**Amendment to the Oath/Declaration:**

**Remarks and Arguments:**

**Amendments to the Drawings:**

FIG. 3

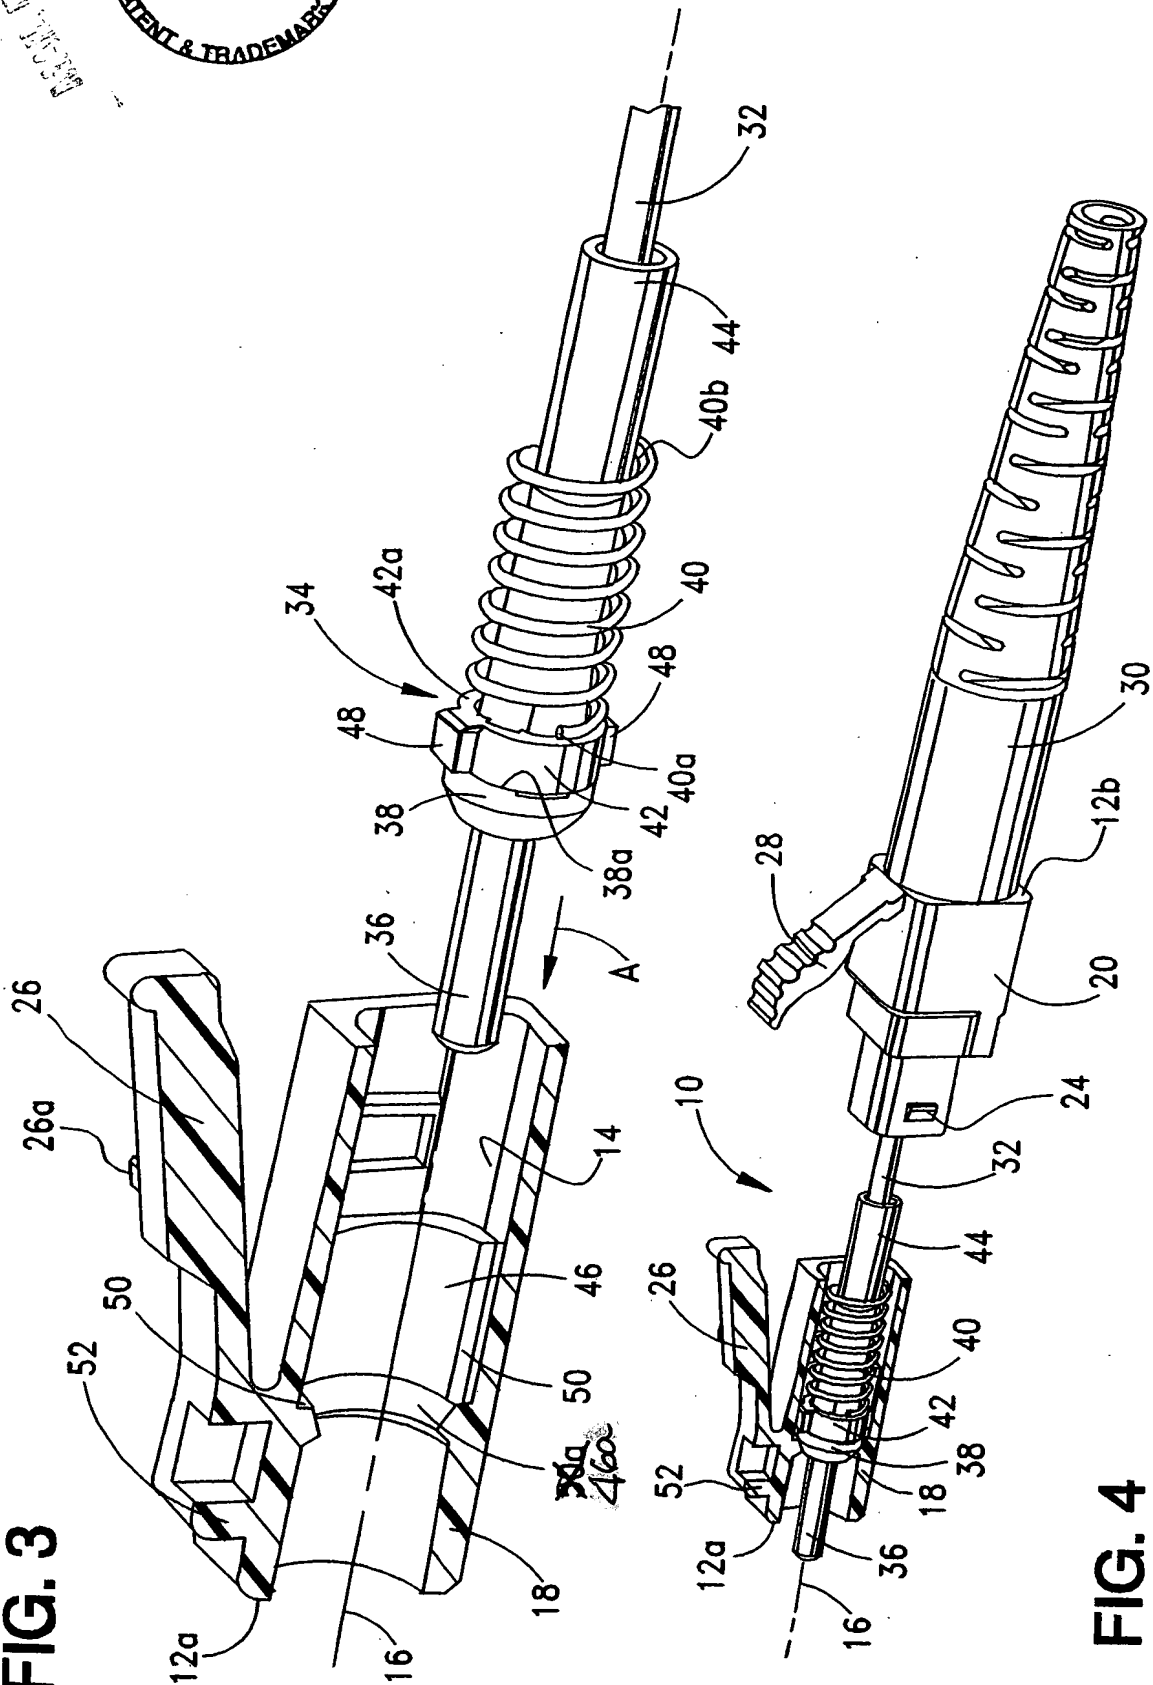
The attached sheet of drawings includes changes to FIG. 3. This sheet, which includes FIGs. 3-4, replaces the original sheet including FIGs. 3-4. In FIG. 3, reference numeral 50a has been changed to 46a.
